RE: RTS for SSD-23480429 at 253-267 Aldington Road Kemps Creek (Westgate)

Attachment 1 – Preliminary stormwater design review comments

1.1. *Trunk drainage width change compared to scheme plan (40 to 20m)*

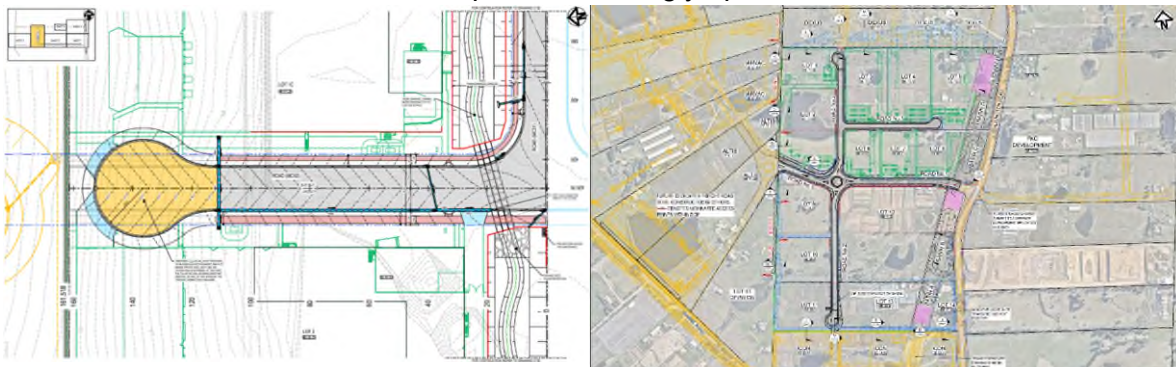
- a. Lack of information on flow velocity and volumes to determine if downsizing of channel is possible. There is no information provided regarding the incoming flows from the north (Fraser's) and east (east of Aldington Road). Note the channel from the north is not removed but is a hybrid channel and detention basin system, which will still need to provide trunk drainage properties.

- b. Sydney Water does not agree with the statement on the EIS (p. 45) regarding the SWC endorsement of the trunk drainage solution. The Sydney Water letter indicates it would endorse the proposal if they were able to prove the flow can be contained within the channel and if the channel adheres to the design guidelines. At this point Sydney Water are not satisfied the proposed design meets the requirements provided in Attachment 1 of the letter.

- c. Stormwater on road no2 will be flowing from Fraser sites before being captured by Oceania site. Sizing of road drainage and interconnection with trunk drainage to be documented and civil plans accordingly updated.

- d. Please provide post-development catchment map to confirm Trunk Drainage Channel Catchment.

1.2. *Issues with the proposed trunk drainage design*

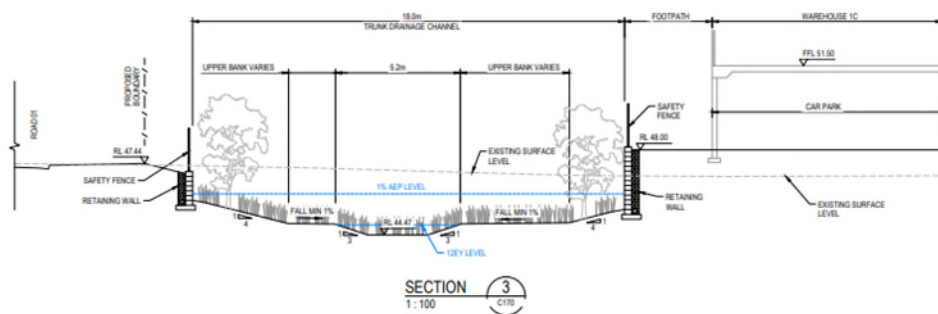
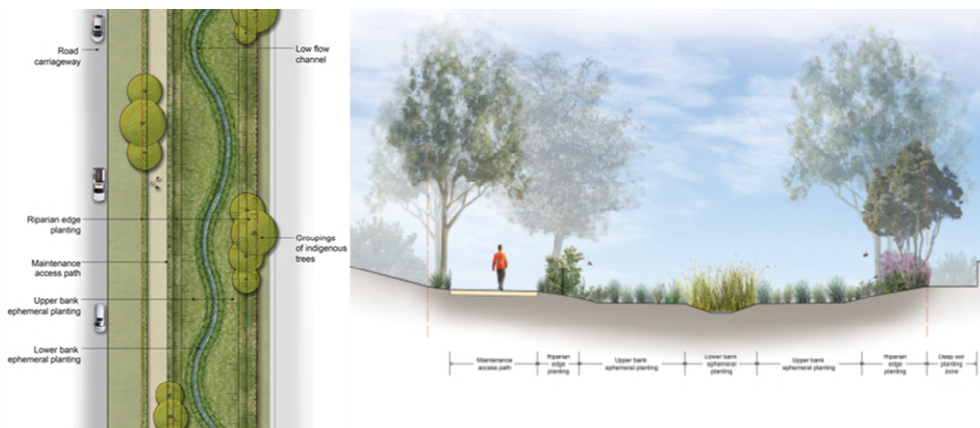
- a. Sydney Water is not satisfied with the current design with the 1% flows touching both the retaining walls. This will impact the structural integrity of the walls during high flow events which could impact the performance of the channels. The 1% flows will need to be contained within the naturalised channel bank and not against any retaining wall.

- b. There is no dedicated maintenance access along the channel. This will need to be included in the updated channel concept design.

- c. The channel having retaining walls with a fence on both sides provides a safety risk if someone is caught in the channel during high flow events. The designer is to ensure there are suitable egress options at regular intervals to reduce risk. Note maintenance access to the channel via stairs (current proposal) will not be supported by Sydney Water, however it would be supported if it was for public safety considerations.
- d. The longitudinal grades under the transmission easement will need to be discussed with Sydney Water. Noting that 15 to 20 metres between drop structures is unlikely to be the best solution due to maintenance issues.
- e. The connection from Frasers will need to be shown in more detail and coordinated with Frasers to minimise erosion potential.

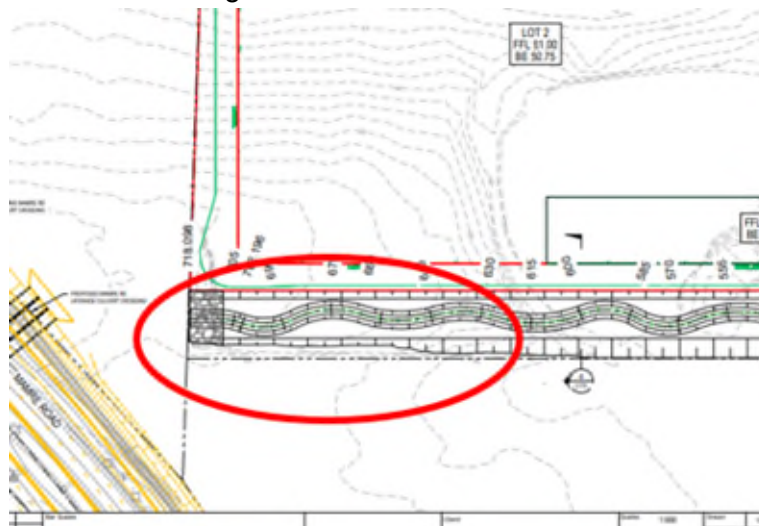
- f. The design of all stormwater outlets into the trunk drainage channel should follow the [Stormwater connections to natural waterways](#) Guidelines. Note the example below does not have sufficient angle with the channel flow.
